## **NUCLEAR REGULATORY COMMISSION**

Title: Advisory Committee on Reactor Safeguards  
Non-Power Production and Utilization Facilities

Date: Wednesday, February 16, 2022

# Overview of the SHINE Medical Isotope Production Facility (Open Session)

# Process Overview

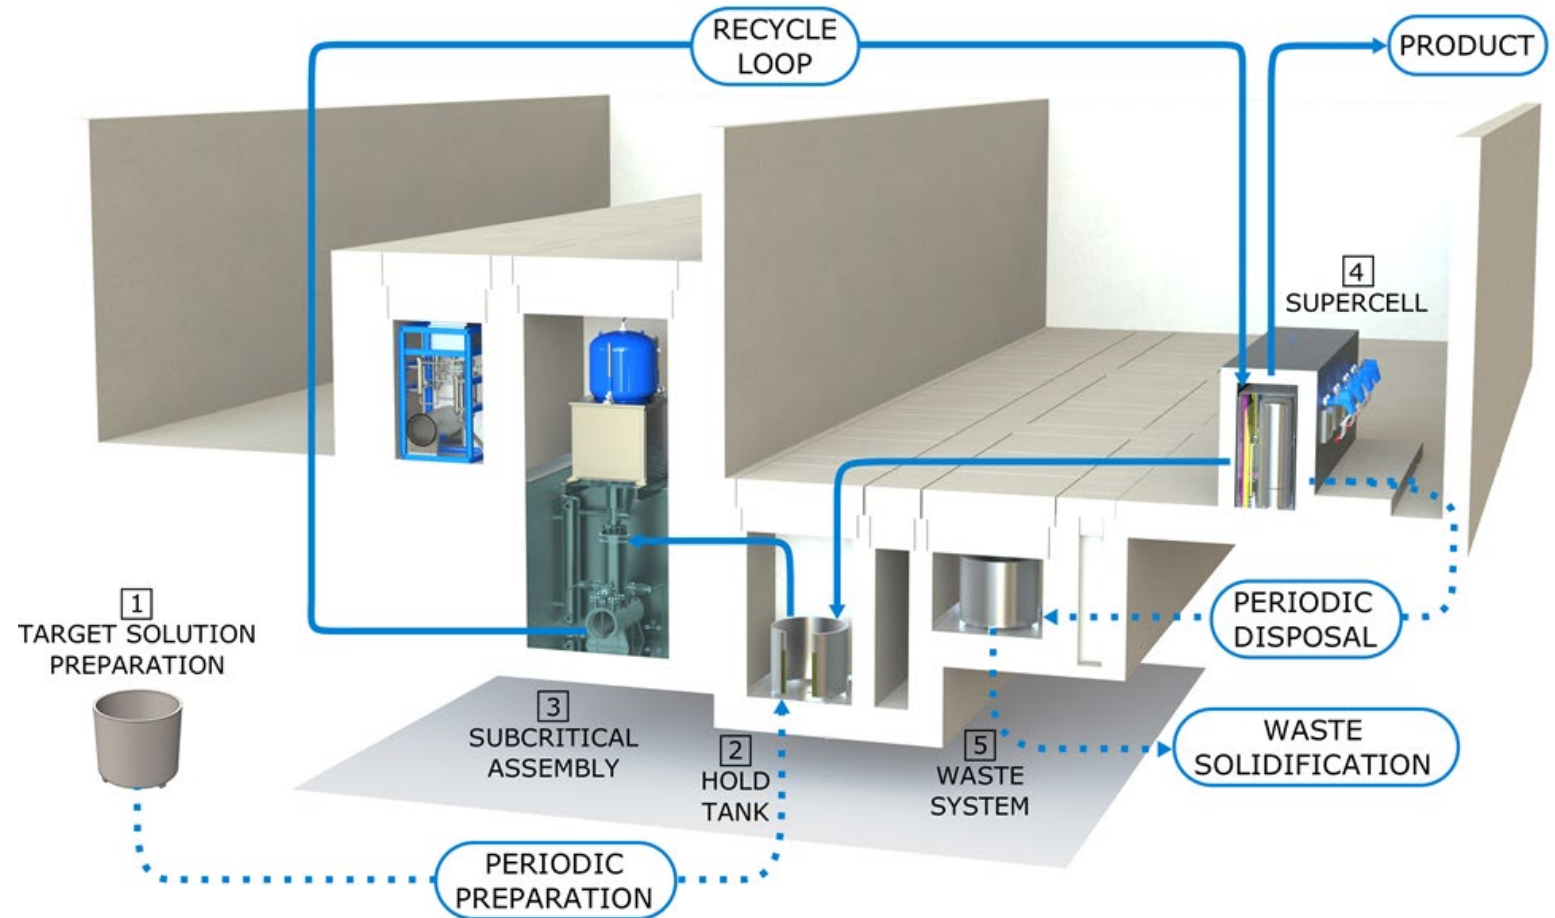
9 MEMBER BROWN: A learning curve again.  
10 The blue line coming out of the supercell and then  
11 back into the hold tank, you talk only about the waste  
12 periodic disposal part of it. You didn't mention what  
13 stuff goes back into the hold tank, if anything.

2 MEMBER MARCH-LEUBA: I just have a short  
3 question. All the holding tanks, they're really  
4 criticality safe volumes, correct? They're really  
5 annulus because they look like a big 55-gallon drum,  
6 but you only store material under the skin, correct?

21 MEMBER HALNON: This Greg Halnon. A real  
22 quick question. Is the only access to the holdup tank  
23 and the annulus next to the right which is a valve  
24 pit. Is it the missile shield's removal? Is that the  
25 only access to those areas?

14 MS. RADEL: Yes, sorry. So the target  
15 solution passes through the extraction column and  
16 flows then back into the hold tank. So the process  
17 doesn't alter the target solution and so it goes right  
18 back to the hold tank for another irradiation cycle.

7 MS. RADEL: Right, they're annular tanks,  
8 favorable geometry.

1 MS. RADEL: The only access is through the  
2 cover plugs.

9 MS. RADEL: Yes. We've located the  
10 majority of equipment that we feel we may need access  
11 to in the valve pits adjacent to the hold tanks. And  
12 those plugs are designed for some access areas for  
13 inspection or maintenance and partial plug removal to  
14 gain access, but you would need to lift portions of  
15 the plug out to gain access to that equipment.
